ADDENDUM NO. 2

November 7, 2022

CENTRAL HIGH SCHOOL HVAC IMPROVEMENTS

This Addendum forms a part of and modifies the Bidding Requirements, Contract Forms, Contract Conditions, the Specifications, and the Drawings dated October 3, 2022, by TowerPinkster. Acknowledge receipt of the Addendum in the space provided on the Bid Form. Failure to do so may subject the Bidder to disqualification.

AUD

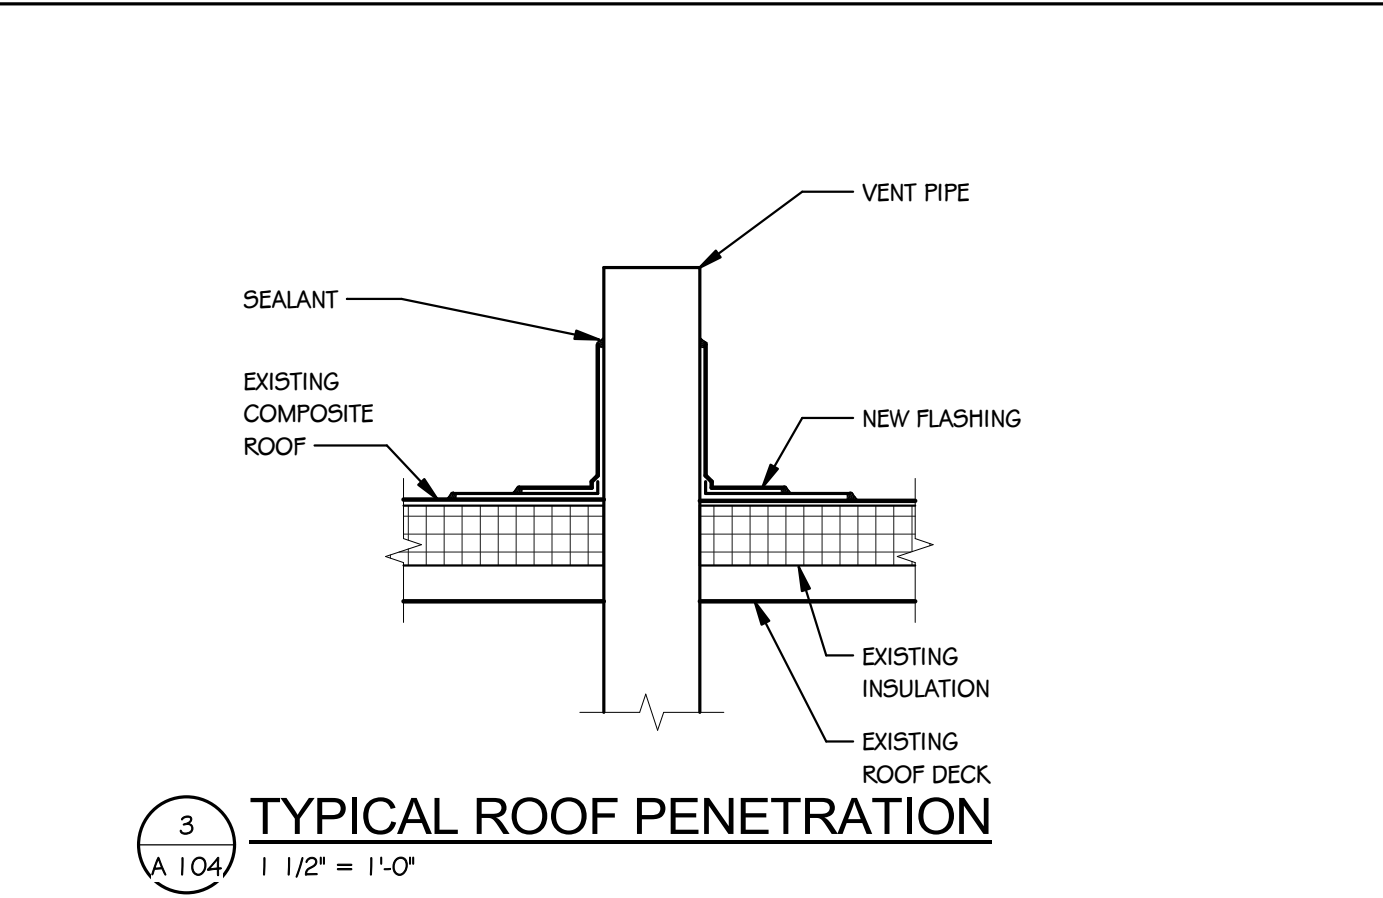
ADD-2 Item No. D-8 - Added Multiple Pipe Routings Through Walls

Added multiple face shell removal and reinstallation of new. Tooth-in, prime and paint to match existing.

SHEET NUMBER
M 202D1
21-806.00

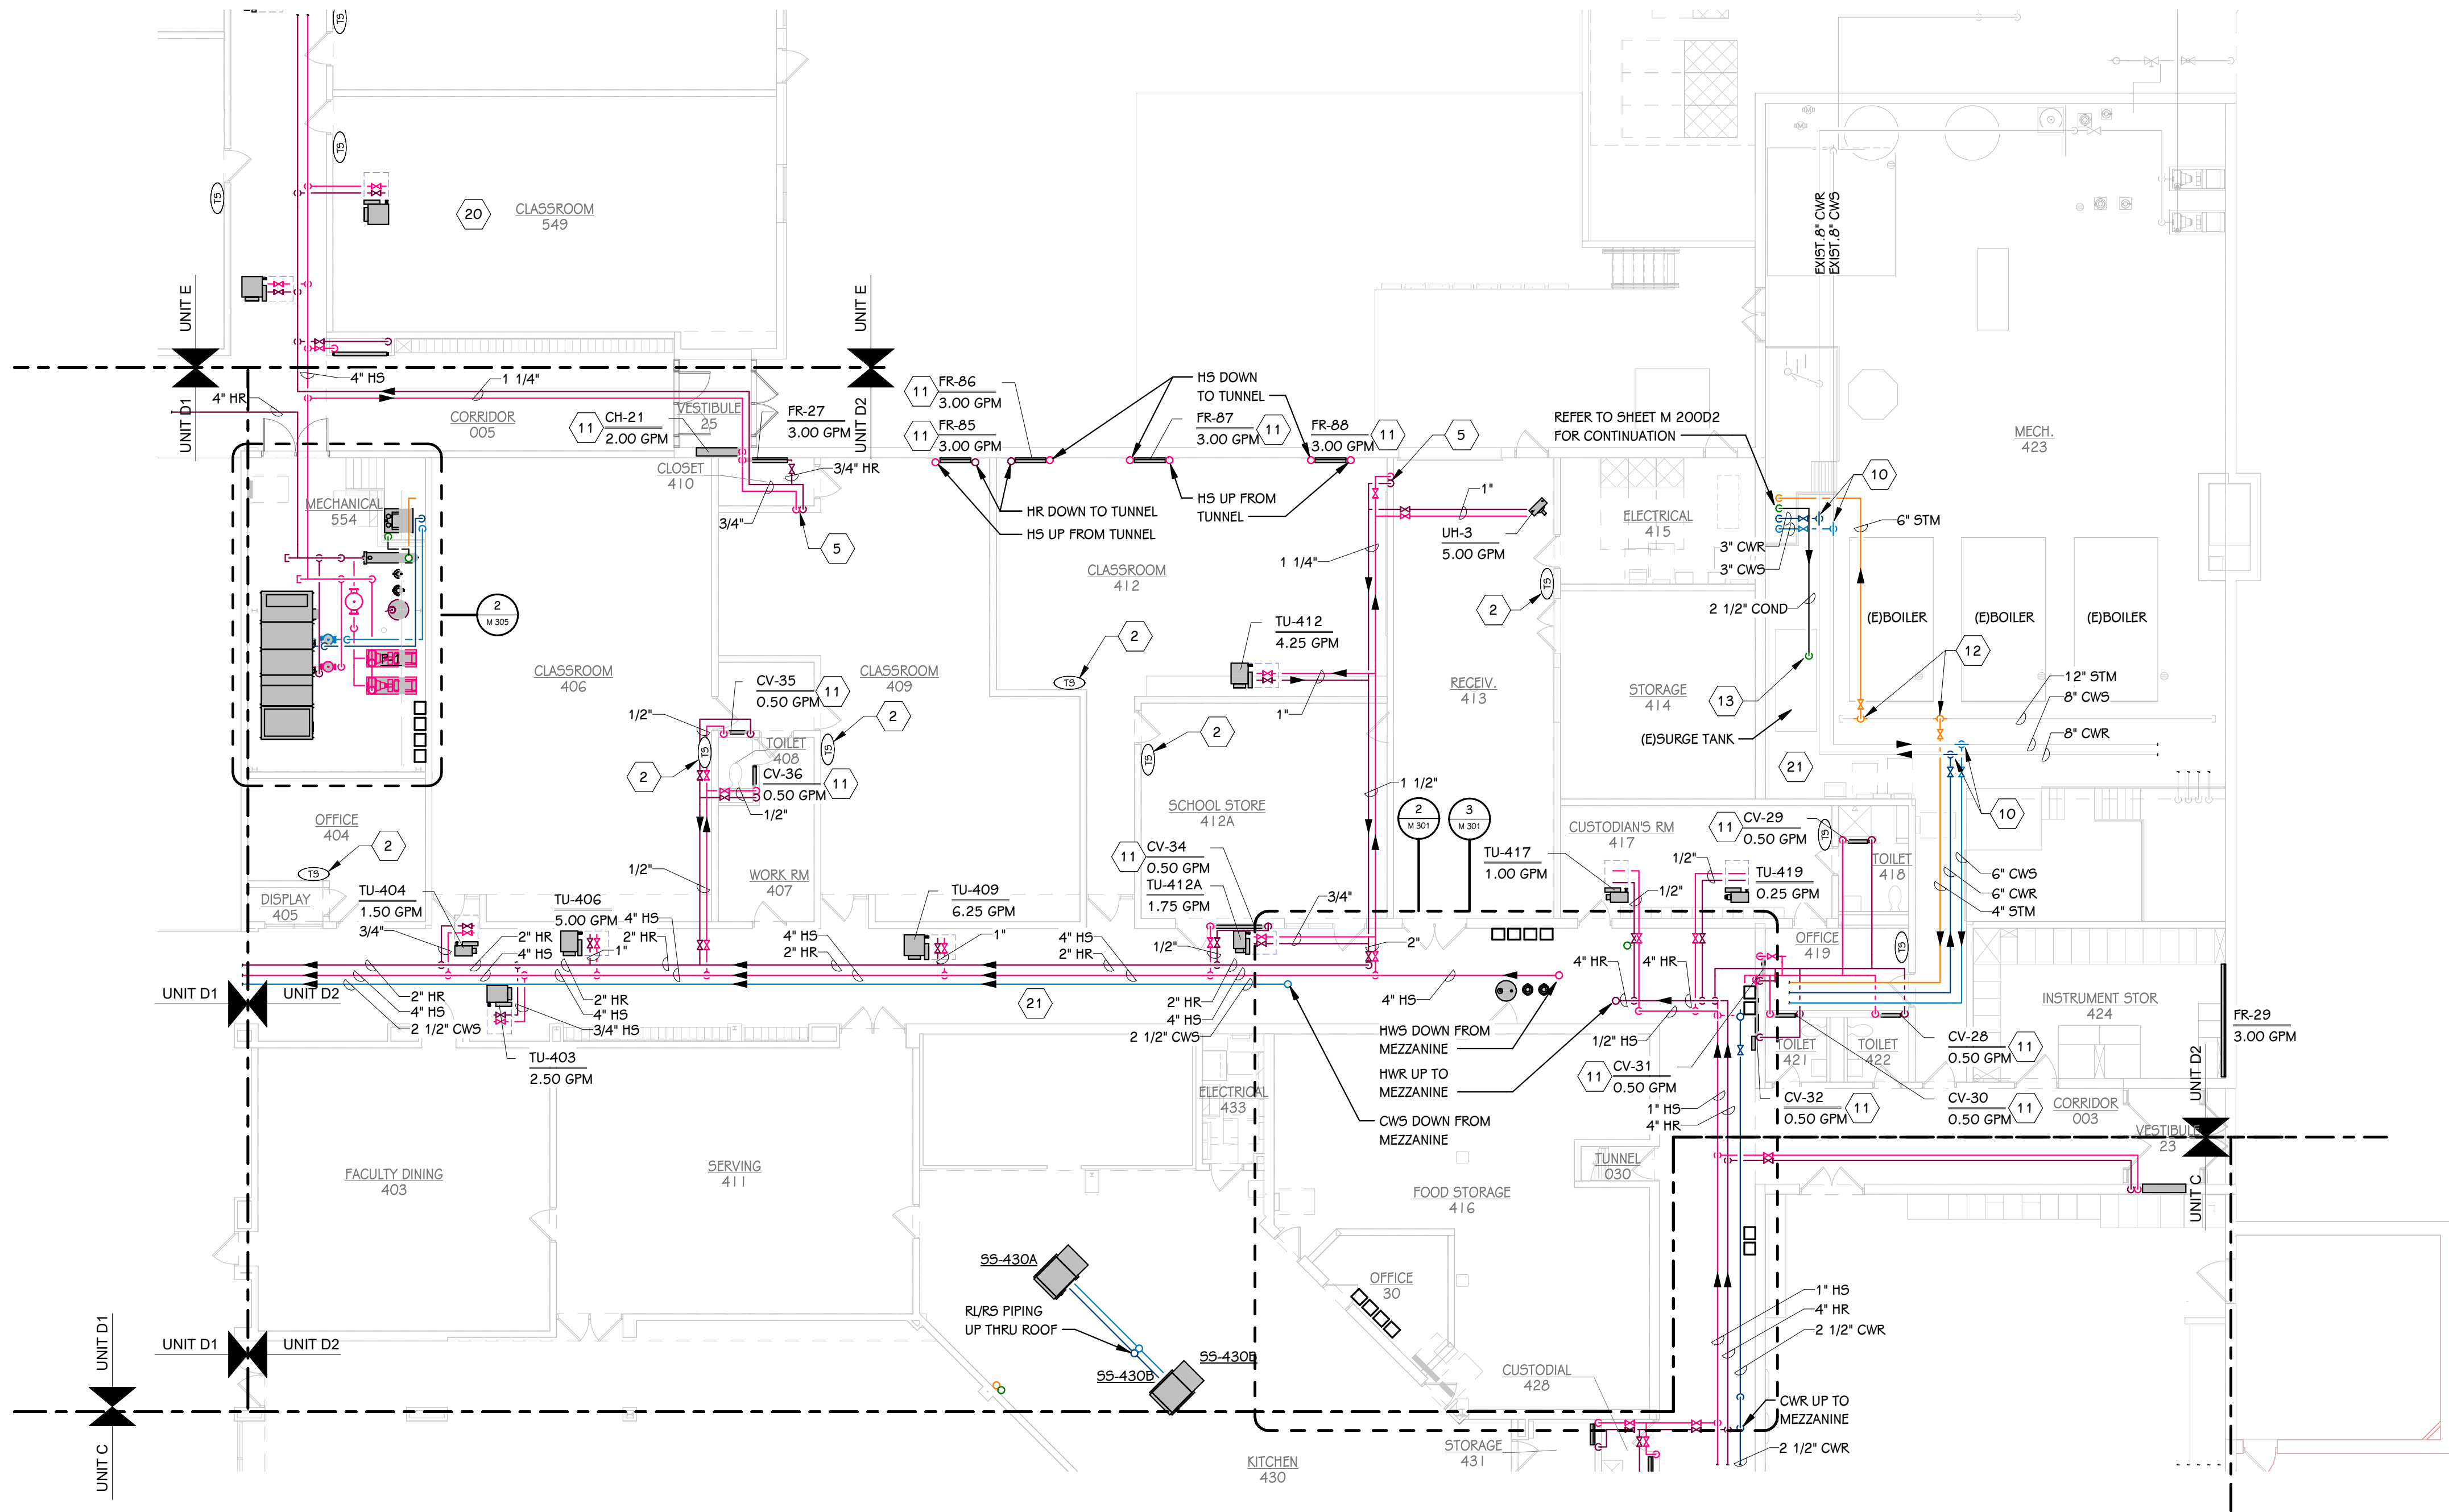
4	RW Lapine	10/19/2022	Drawing M202D1 has numerous piping branches as well as mains without line sizes. Please advise. Branches noted - heating coil 505, FR-508, FR-506, and mains above Vestibule 24 have no designated sizing	Refer to Addendum 2
5	RW Lapine	10/19/2022	Drawing M202C indicates no piping sizes on the chilled water return line in the corridor headed north to unit D2. Mains are depicted as continuation on M202C drawing, but they appear to be dead ends within the lower fan room without pipe sizing as well. This is shown in detail 2 Print M301	Refer to Addendum 2
6	RW Lapine	10/19/2022	Heating supply and Heating return are depicted in detail 2 Print M301 coming from unit C are not indicated where to be routed for tie in to the existing system. Piping appears to be dead ended within the mechanical space. Please clarify	Refer to Addendum 2
7	RW Lapine	10/19/2022	M301 Upper fan room detail 3-200 shows 4" HS, 4" HR, 4"CWR, 4" CWS turning down within the upper right hand corner. Are we to assume 4" connections continued through drawing M202 in the office 419 to the connecting corridor to Mechanical room 423? No line sizes are noted on these drawings. Please clarify.	Refer to Addendum 2

3 MECHANICAL POWER PLAN - MECHANICAL 554
1/4" = 1'-0"

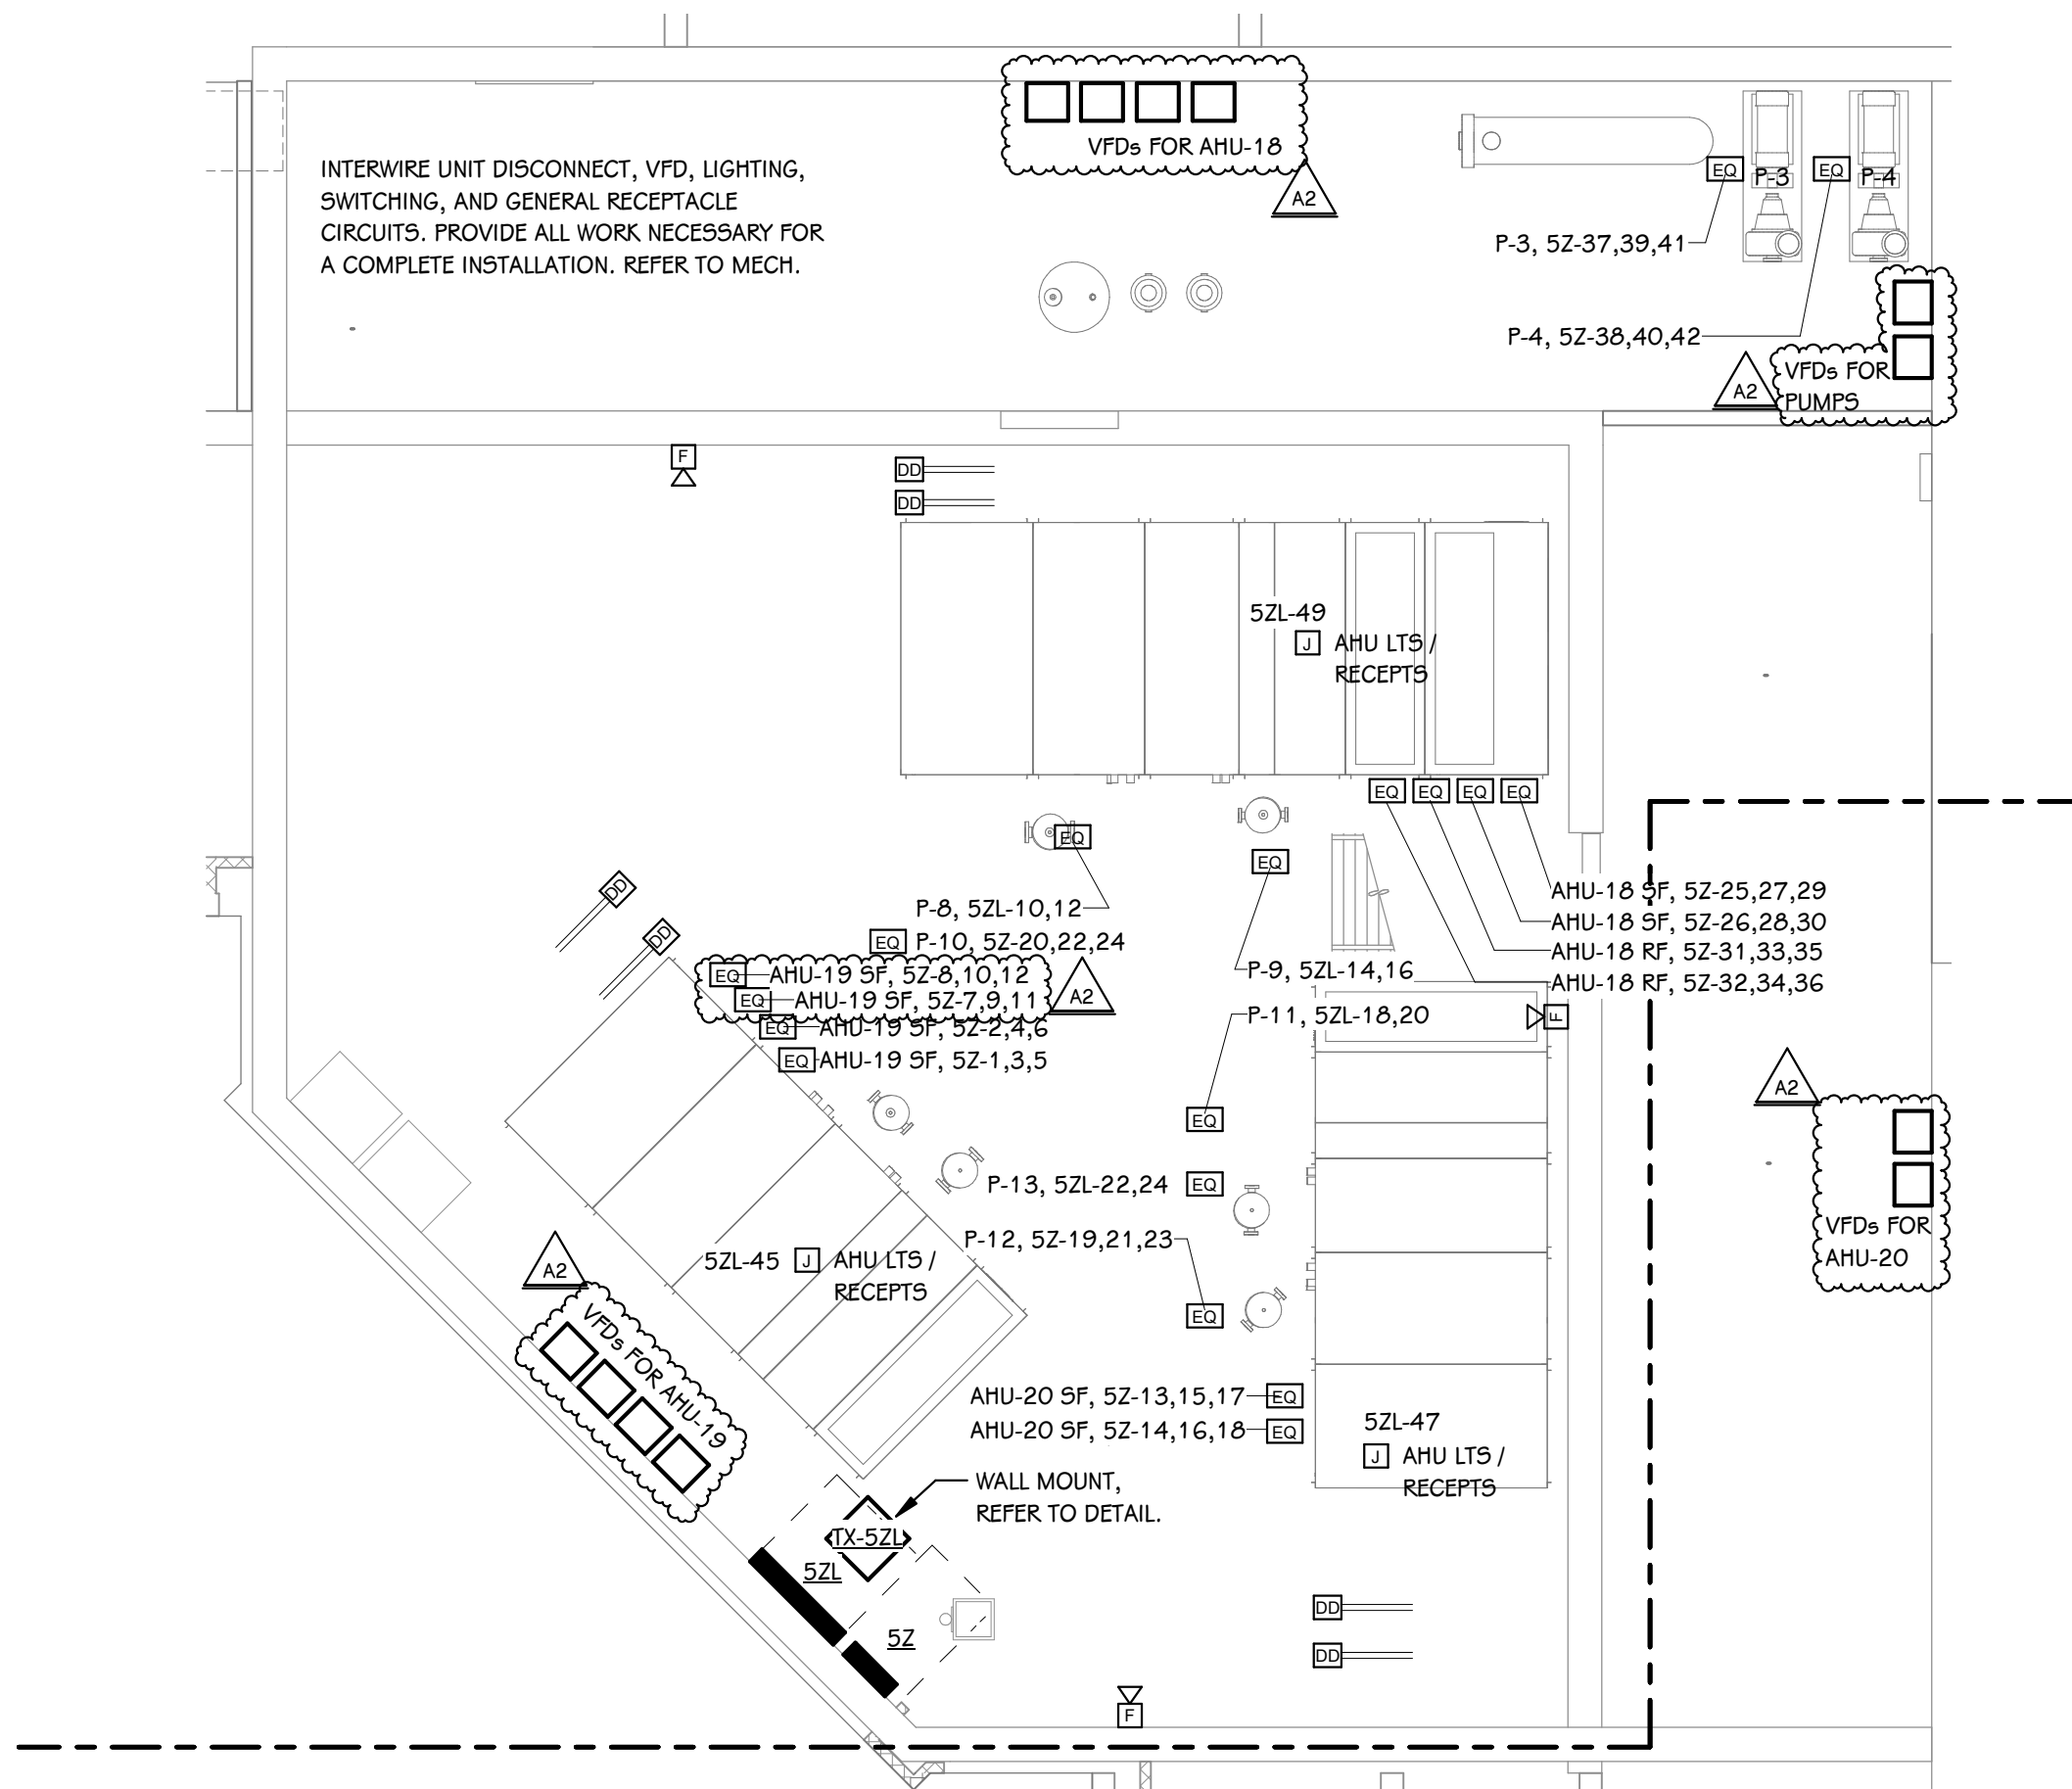
ADD-2 Item No. D-6 - Revise Electrical Connections in Mechanical 554

Added circuit for receptacles to 5ZL-21

Revised pump locations to coordinate with mechanical
